# Access Compliance Report

## Public Rights-of-Way

Intersection ID: 48792	Main Street: WOODLAND_WATCH_CT	Cross Street: COMMUNITY_HOUSE_RD	Location: NW
ADA ID: 854BBB694204	Ramp Type: Perp	Initial Pass/Fail: Fail	Overall Compliance: No
Codes/Mitigation Info/Possible Solution		Field Measurements/Component Compliance	
Severity Score: 1.25

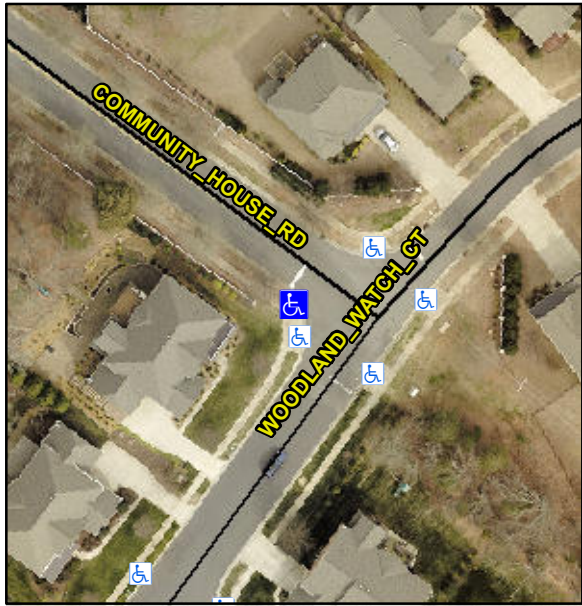
Possible Solutions:					
	Remove & Replace Entire Ramp.					
	Surveyor Notes:					
	N/A					
	PROW/ADA:					
	R304.5.3					
	Street 1 Name		COMMUNITY HOUSE RD			
	Stop Condition-Street 2		StopSign			
	Street 2 Name		N/A			
	Stop Condition-Street 1		N/A			
Total Cost:		\$	1850.00

Compliance	Description	Data	Compliance	Description	Data
N/A	Ramp Length (in)	64.0	Yes	Ramp Slope (%)	7.9
Yes	Ramp Width (in)	48.0	No	Ramp XSlope (%)	4.9
N/A	Flare Type LT	N/A	N/A	Flare Type RT	N/A
N/A	Flare Slope LT (%)	N/A	N/A	Flare Slope RT (%)	N/A
N/A	Flare Traversable LT?	N/A	N/A	Flare Traversable RT?	N/A
N/A	Landing Length (in)	N/A	N/A	DWS Provided?	N/A
N/A	Landing Width (in)	N/A	N/A	DWS Contrast?	N/A
N/A	Landing Slope (%)	N/A	N/A	DWS Length (in)	N/A
N/A	Landing X Slope (%)	N/A	N/A	DWS Full Width?	N/A
N/A	Landing Curb? (Y/N)	N/A	N/A	DWS Offset (in)	N/A
N/A	Shared Landing?	N/A			
N/A	Gutter Ponding?	N/A	N/A	Gutter Slope (%)	N/A
N/A	Gutter Lip Ht (in)	N/A	N/A	Gutter X Slope (%)	N/A
N/A	Painted X Walk1?	No	N/A	Painted X Walk2?	N/A
	X Walk 1 Direction	To NE		X Walk 2 Direction	N/A
N/A	X Walk 1 Width (in)	N/A	N/A	X Walk 2 Width (in)	N/A
	X Walk 1 Slope (%)	7.8		X Walk 2 Slope (%)	N/A
	X Walk 1 X Slope (%)	0.3		X Walk 2 X Slope (%)	N/A
